## PLANNING AND DEVELOPMENT SERVICES STAFF REPORT

**SUBJECT: Ruth's Chris Site Plan for City Council Approval  
(314 S. Fourth Avenue)  
File No. SP14-010**

## 314 S. Fourth Avenue Redevelopment for Ruth's Chris Steak House Restaurant

### Design Review Board Comments

**Proposed Ruth's Chris Steak House**

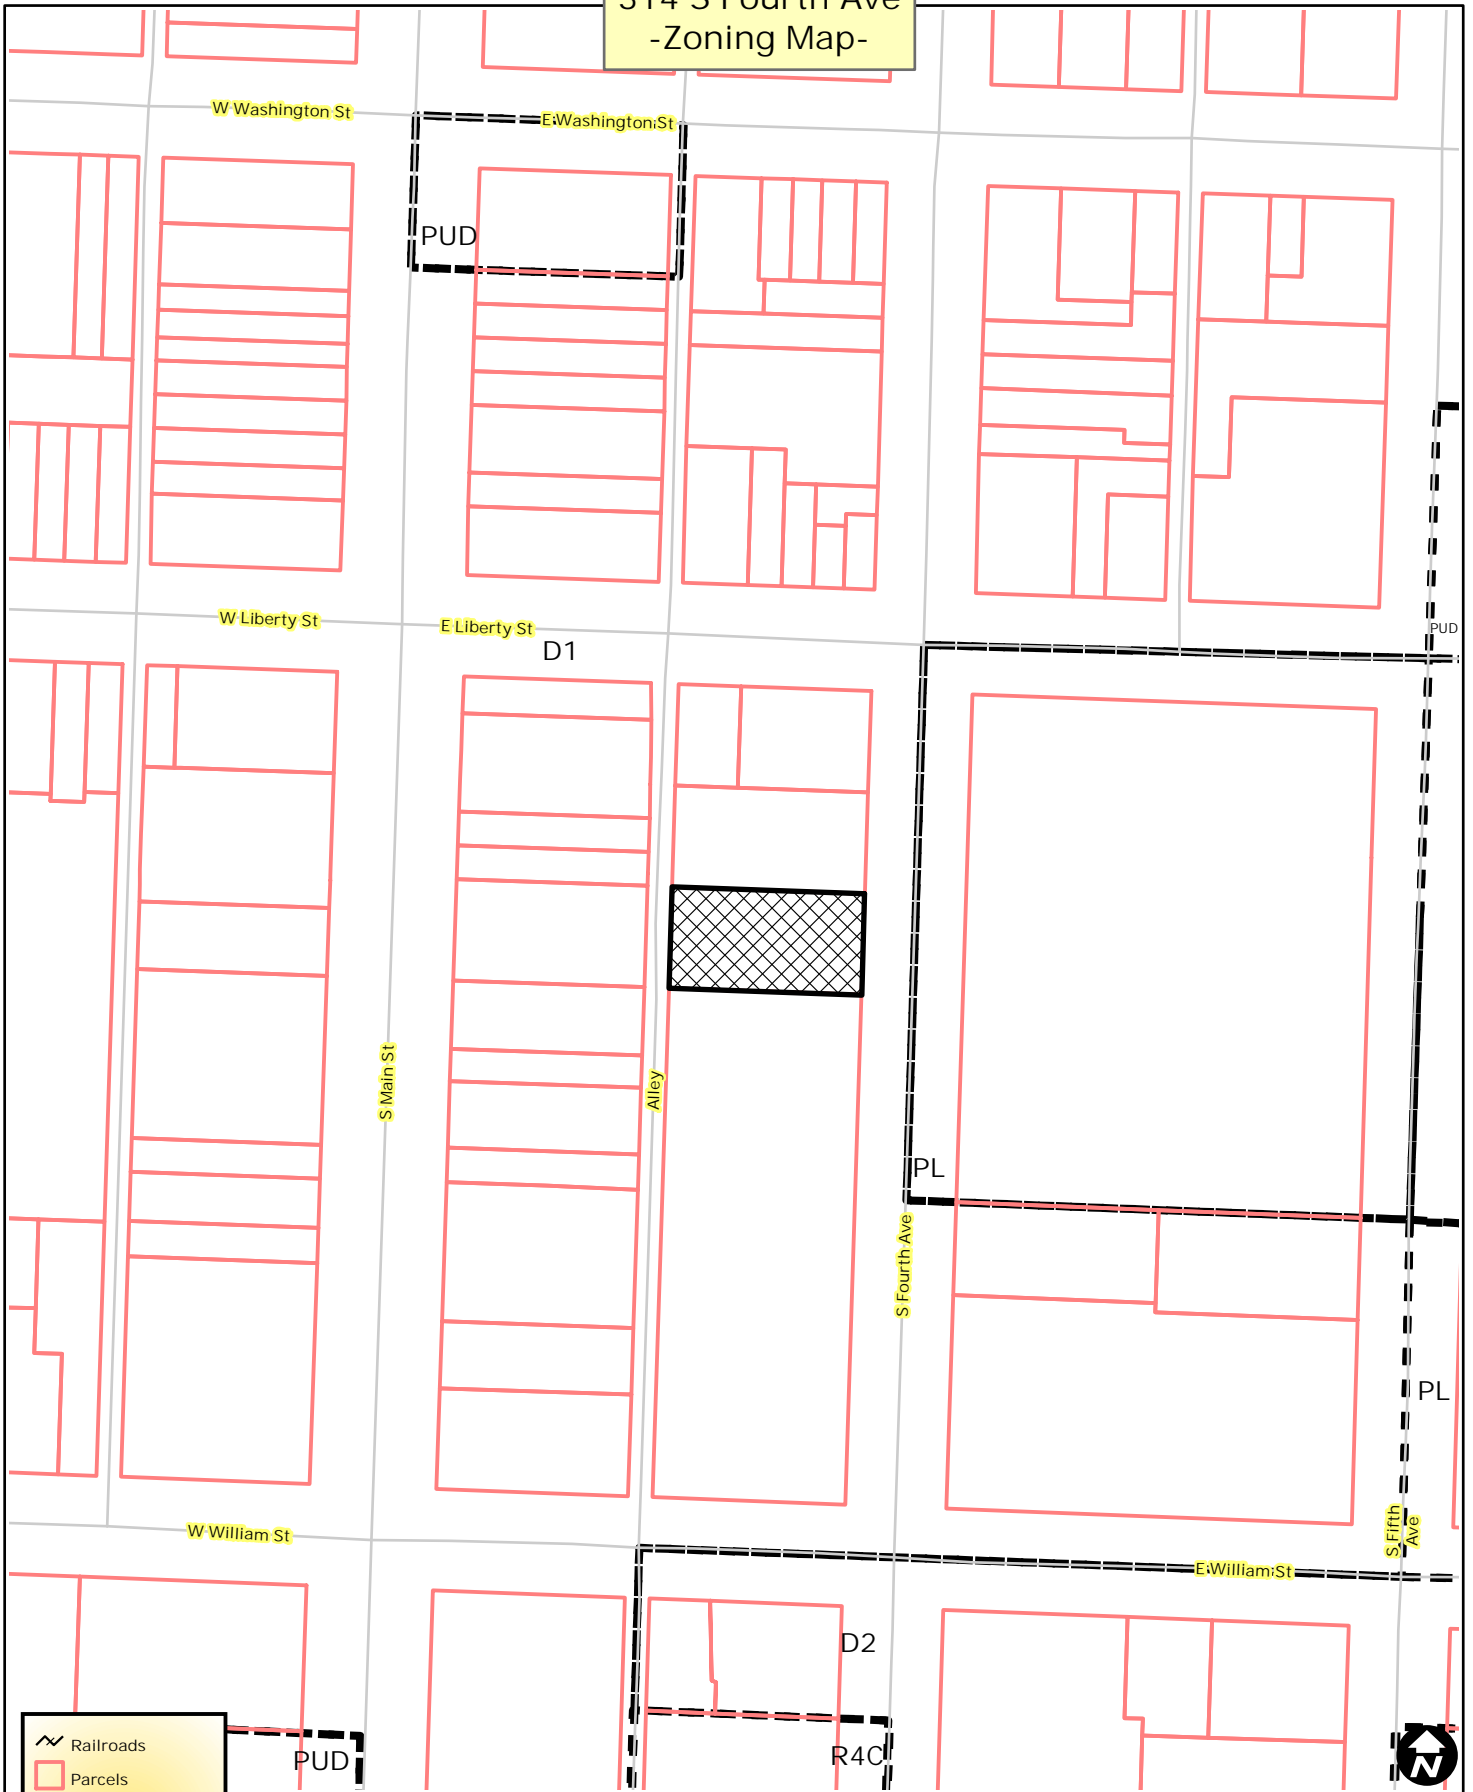
The Board also suggested adding sidewalk seating and opening windows on the first floor level. The building faces east (no sun) and this restaurant plans to open for dinner only. In addition, this section of Fourth Avenue has heavy bus and vehicular traffic at fairly high speeds and limited sidewalk area. While we did consider these options, we concluded that in order to guarantee the type of dining experience that our customers expect, we needed to provide a protected environment free from unwanted noise and odors. The entire first floor will be clear windows to maximize pedestrian visibility. Plans also include a staffed valet service during hours of operation which will also provide increased activity and vibrancy to the streetscape.

The first exhibit shows the existing building façade. The second exhibit shows our proposed elevation side-by-side with a sample photo taken directly from the Midtown Character District Downtown Design Guidelines. I think these images are very similar with our proposed façade being slightly more modern and updated.
